**STAFF RECOMMENDATION**  
**3609 Richland Avenue**  
**Lot 12, Richland Hall Development**  
**September 20, 2017**

**Application:** New construction—infill and outbuilding  
**District:** Richland-West End Neighborhood Conservation Zoning Overlay  
**Council District:** 24  
**Map and Parcel Number:** 10409030100  
**Applicant:** Chad Gore, Mike Ford Builders  
**Project Lead:** Melissa Baldock, melissa.baldock@nashville.gov

**Description of Project:** Application is to construct a new single family infill and an outbuilding.

Figure 2. Overall site plan for the 22 infill houses planned for the Richland-West End Neighborhood Conservation Zoning Overlay. The red box indicates the site currently under consideration.

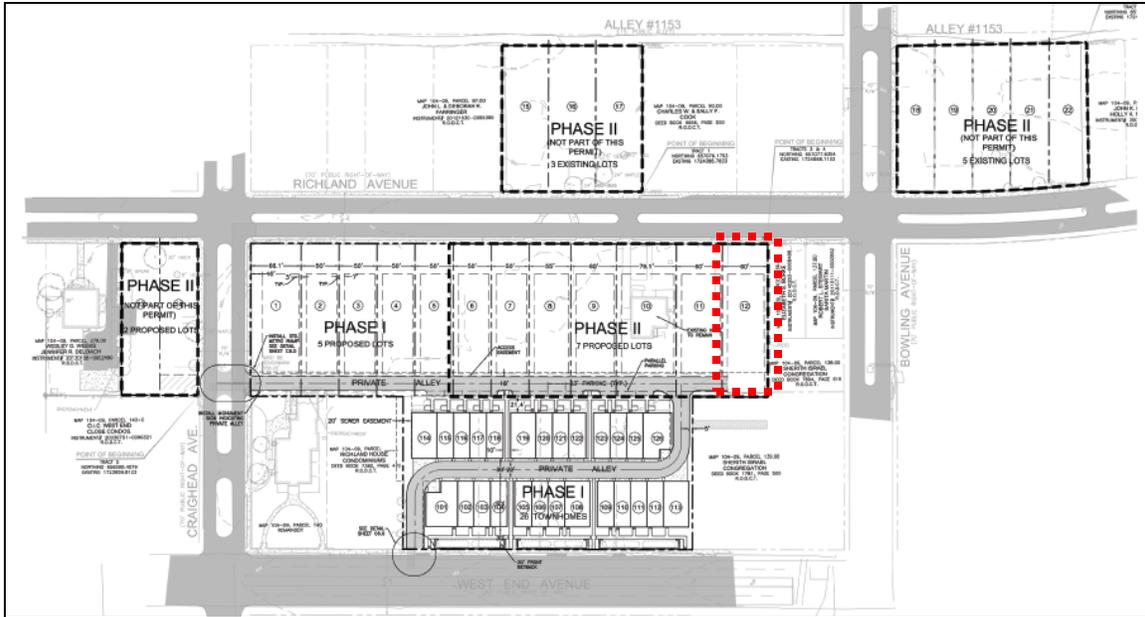
Setback & Rhythm of Spacing: The proposed infill will meet all base zoning setbacks. The front setback for this development is proposed to be fifty-three feet, eight inches (53’8”). This matches the front setback for Lot 11 next door, which MHZC approved in June 2017. Staff finds that the proposed front setback meets the design guidelines and the historic context.

**SITE PLAN**

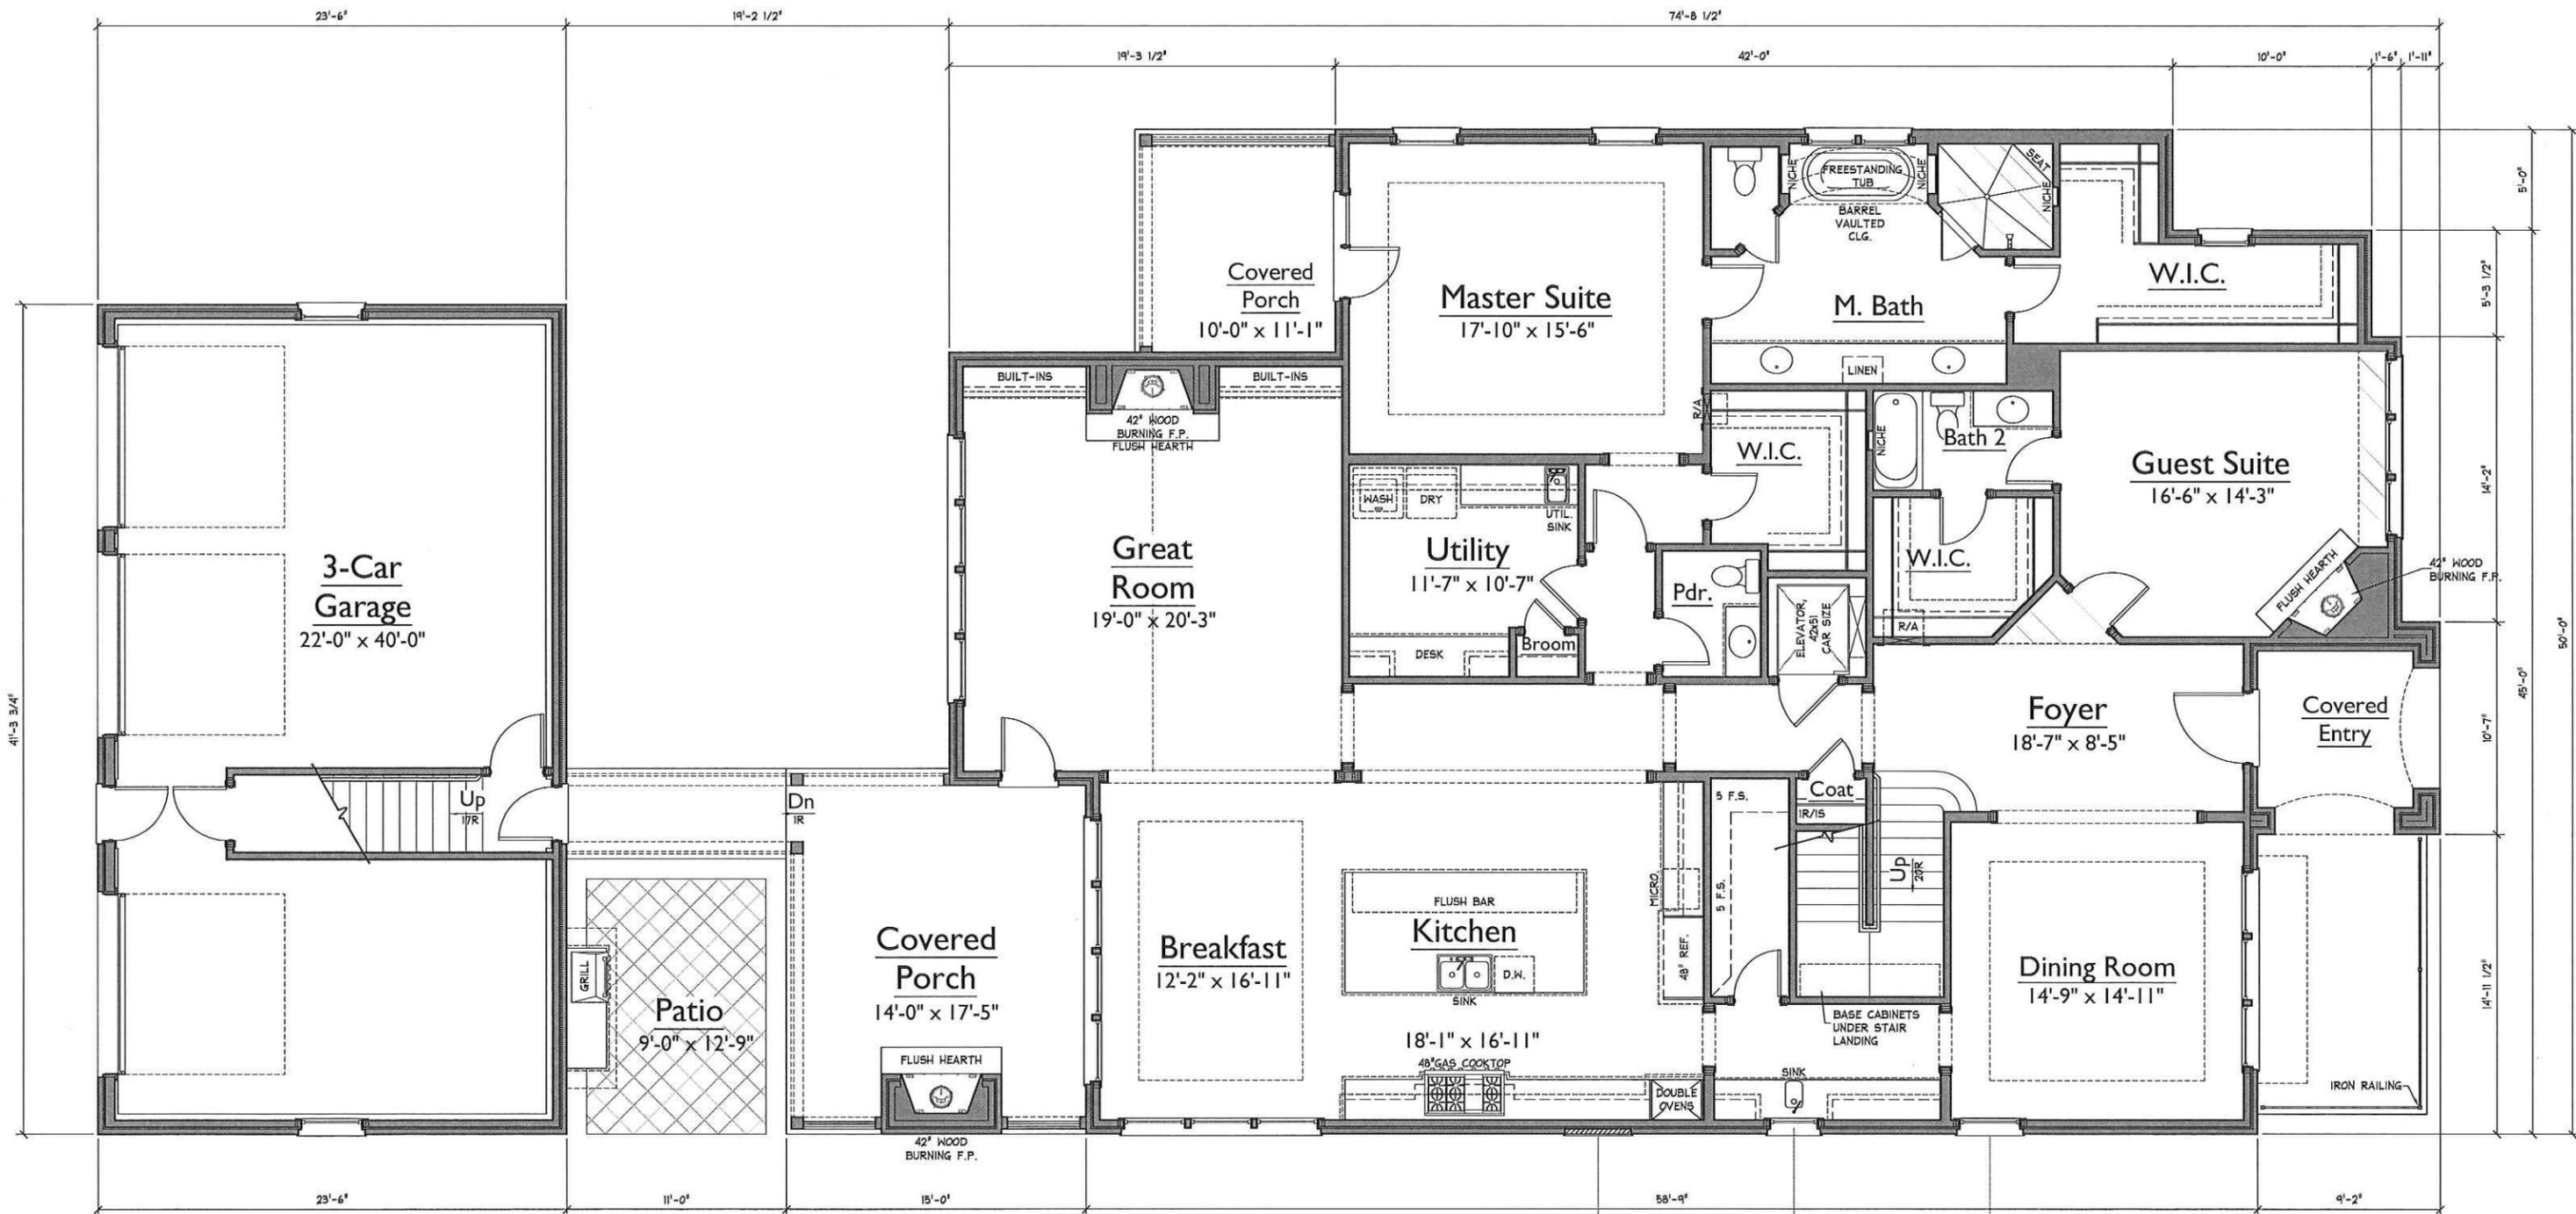
The infill will five feet (5’) from each of the side property lines. It will be over sixty-five feet (65’) from the rear property line. Staff finds that the proposed setbacks to be similar to the immediate historic context and to meet Section II.B.1.c. of the design guidelines.

**Appurtenances & Utilities:** The driveway at the rear will be concrete, as will the walkway leading to the front porch from the sidewalk. No fencing was indicated on the site plan. The location of the HVAC location was not indicated on the plans, and staff recommends approval of the placement. With this condition, staff finds that the infill meets Section II.B.1.i. of the design guidelines.

<b>MINIMUM</b>	<b>PROPOSED</b>
<b>Building located towards rear of lot</b>		Yes
<b>Space between principal building and DADU/Garage</b>	20'	11'*
<b>Rear setback</b>	20'	32'2"
<b>L side setback**</b>	5'	5'
<b>R side setback**</b>	5'	5'
<b>How is the building accessed?</b>		From new private alley
<b>If the building is two-bay and the vehicular doors face the street, are there two different doors rather than one large door?</b>		N/A

**ELEVATIONS**

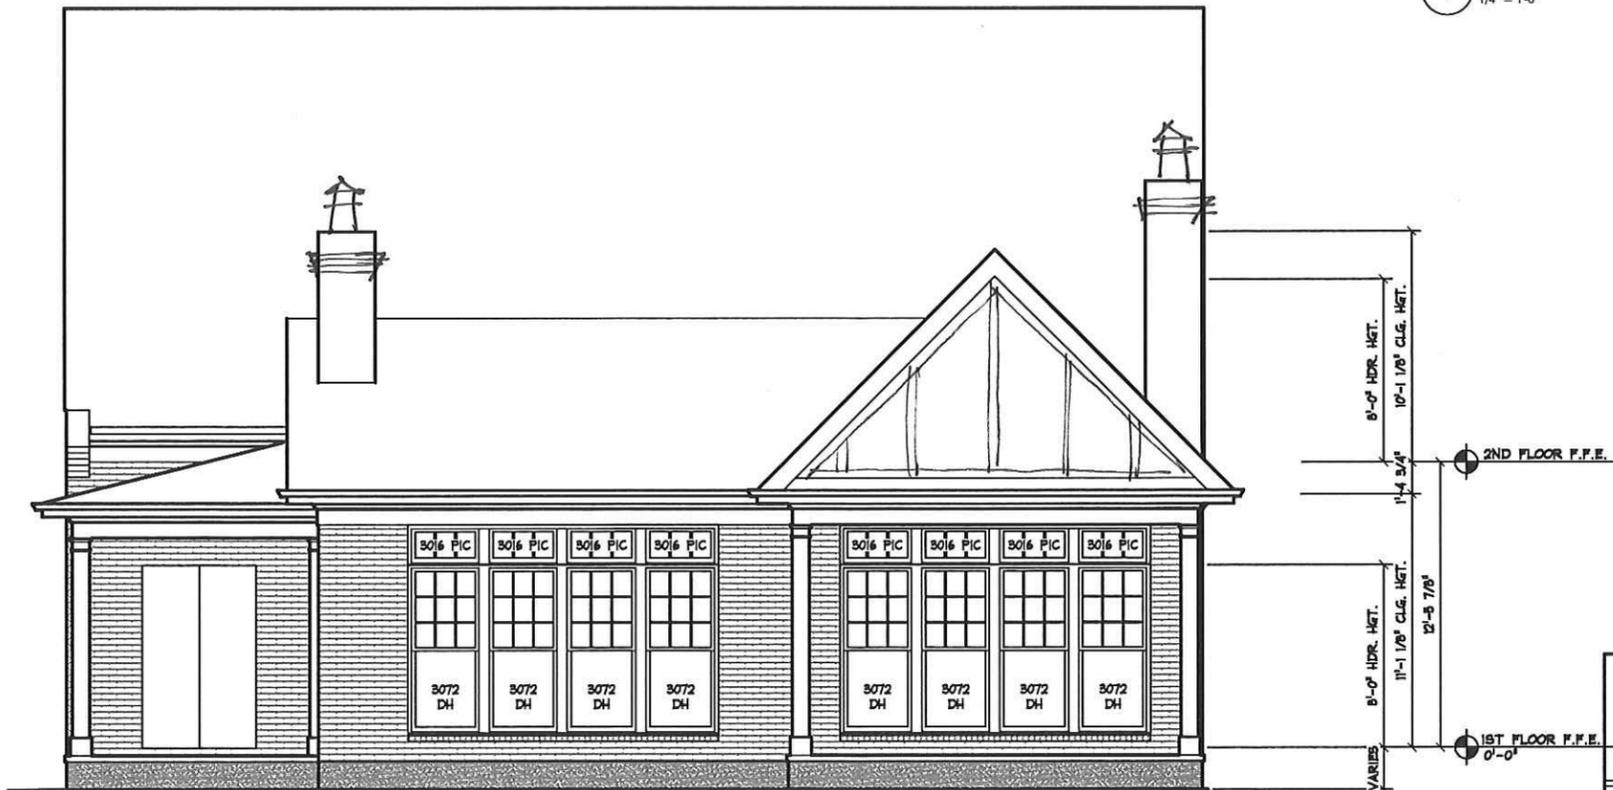
**Height & Scale:** The proposed infill will be a tall one-and-a-half house, with a maximum height of thirty-three feet, ten inches (33'10") above the foundation at the front, and approximately thirty-seven feet (37') above grade. The infill will have an eave height of fifteen feet (15') above the foundation, eighteen feet (18') above the grade. The foundation height will vary due to grade, but will be between three feet, three inches (3'3") and four feet, six inches (4'6"). This is taller than what is typical, and staff recommends that the applicant work with MHZC staff to ensure that during construction, the foundation height is appropriate to the site and matches the historic context. With this condition, staff finds that the proposed height is similar to the heights of historic houses in the immediate vicinity, which range from thirty to forty-four feet (30' – 44'). It is also in keeping with what has been approved in the past for the infill houses in this development.

The lot is sixty feet (60') wide. The house will be forty-five feet (45') wide at the front. A one-story bay extends the house width to fifty-feet (50') ten feet (10') back from the front of the house. Twenty feet (20') back from the front of the house, the second story portion of the house becomes two stories. Staff finds that the one-story wider portion of the house is appropriate because it reads like a bay and it is significantly shorter than the main part of the house. The two-story portion is pushed back twenty-feet (20') from the front, and therefore will not have a great impact on the sense of the house's width at the front. In addition, the proposed width is within the range of the widths of the historic houses in the immediate vicinity, which range from thirty-eight to sixty-five feet (38'-50').

Staff recommends verification of the construction height of the foundation and floor systems in the field to ensure that the finished floor line of the new construction is compatible with the historic context. With this condition, staff finds that the height and scale meet Sections II.B.1.a.andII.B.1.b. of the design guidelines.

Staff recommends approval of a brick sample, stone sample, all windows and doors, the roof shingle color, and the materials of the porches' floor and stairs. With these approvals, staff finds that the known materials meet Section II.B.1.d. of the design guidelines.

**Roof form:** The infill's primary roof form is a cross gable with a 14/12 pitch. The sides have double gables that also have 14/12 pitch. The front dormer will be a shed dormer with a 11/12 pitch; the dormer will be inset two feet (2') from the wall below. The front stoop will have a gabled entry with a 13/12 pitch. The rear porch roof will be a 3/12 hip. Staff finds that the proposed roof forms are appropriate for an infill house in the overlay, and finds that the roof forms meet Section II.B.1.e. of the design guidelines.

**Proportion and Rhythm of Openings:** The proposed windows on the infill are generally twice as tall as they are wide, thereby meeting the historic proportion of window openings. There are no large expanses of wall space without a door, window, or faux window opening. All double and triple window openings have a four to six inch (4"-6") mullion in between them. Staff finds that the infill's proportion and rhythm of openings meet Section II.B.1.g. of the design guidelines.

**GARAGE ELEVATIONS**

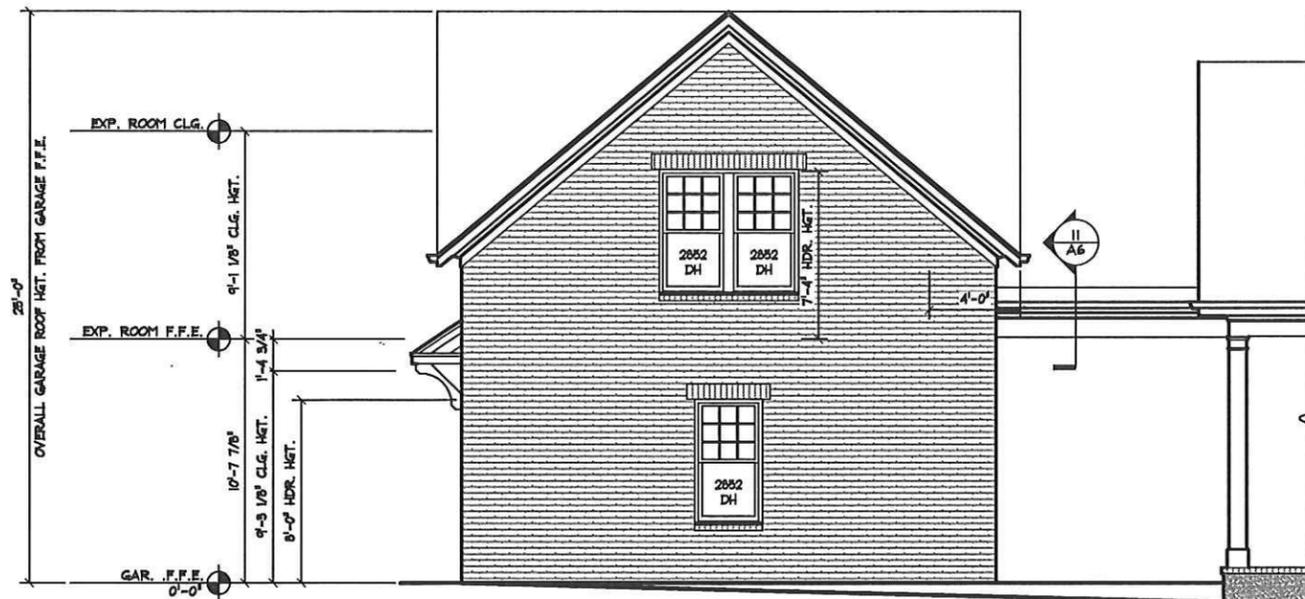
\*The Commission typically requests to see at least twenty feet (20') between the primary structure and the outbuilding. The applicant is proposing just eleven feet (11') in between the structures. The Commission has approved a distance of ten feet (10') in between the primary structures and the outbuildings for Lots 1, 2, 3, 4, 5, 6, and 11 of this development. Staff recommends approval of the distance between the infill and the outbuilding for Lot 11. The overall development is creating a new alley at the rear of the lots, which will make the back portion of the lot unavailable for building. Approximately the back thirty feet (30') of the lot is used for the alley. In addition, there is a utility easement in between the alley and the outbuilding. The outbuilding cannot be pushed any further to the rear because of the new alley and the easements on the property. Therefore, staff finds that the distance in between the primary house and the outbuilding to be sufficient.

<b>Infill</b>	<b>Potential maximums (heights to be measured from grade)</b>	<b>Proposed (should be the same or less than the lesser number to the left)</b>
<b>Ridge Height</b>	37'	25'	25'
<b>Eave Height</b>	18'	17'	13'9"

With the final approval of all materials, staff finds that the proposed outbuilding meets Section II.B.1.h of the design guidelines.
